Access Compliance Report

Public Rights-of-Way

(Curb Ramps)

Intersection ID: 14714	Main Street: E_MOREHEAD_ST	Cross Street: HARDING_PL	Location: SW
ADA ID: 2F3DCA104A9C	Ramp Type: Perp	Initial Pass/Fail: Pass	Overall Compliance: No
		Severity Score: 5.25

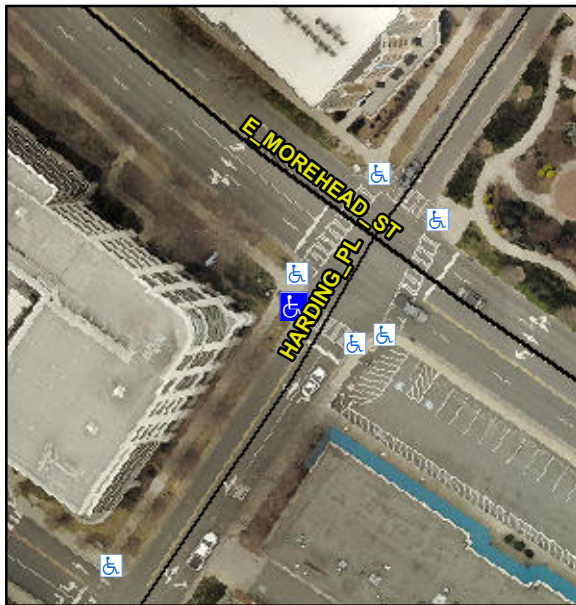
**Not Found, R304.5.3, R304.2.2-Perp,
R304.3.2-Para, R304.2.3, R305.1.4**

Compliance	Description	Data	Compliance	Description	Data
N/A	Ramp Length (in)	96.0	Yes	Ramp Slope (%)	5.3
Yes	Ramp Width (in)	49.0	No	Ramp XSlope (%)	2.4
N/A	Flare Type LT	Sloped	N/A	Flare Type RT	N/A
N/A	Flare Slope LT (%)	3.3	No	Flare Slope RT (%)	10.8
N/A	Flare Traversable LT?	Yes	N/A	Flare Traversable RT?	Yes
Yes	Landing Length (in)	72.0	Yes	DWS Provided?	Yes
Yes	Landing Width (in)	49.0	Yes	DWS Contrast?	Yes
No	Landing Slope (%)	3.7	Yes	DWS Length (in)	25.0
No	Landing X Slope (%)	2.3	No	DWS Full Width?	No
N/A	Landing Curb? (Y/N)	No	Yes	DWS Offset (in)	1.0
N/A	Shared Landing?	No			
Yes	Gutter Ponding?	No	Yes	Gutter Slope (%)	1.9
Yes	Gutter Lip Ht (in)	0.0	No	Gutter X Slope (%)	2.1
N/A	Painted X Walk1?	Yes	N/A	Painted X Walk2?	N/A
	X Walk 1 Direction	To SE		X Walk 2 Direction	N/A
N/A	X Walk 1 Width (in)	112.0	N/A	X Walk 2 Width (in)	N/A
	X Walk 1 Slope (%)	0.7		X Walk 2 Slope (%)	N/A
	X Walk 1 X Slope (%)	1.1		X Walk 2 X Slope (%)	N/A

**Remove & Replace Entire Ramp.
Remove & Replace Gutter.**
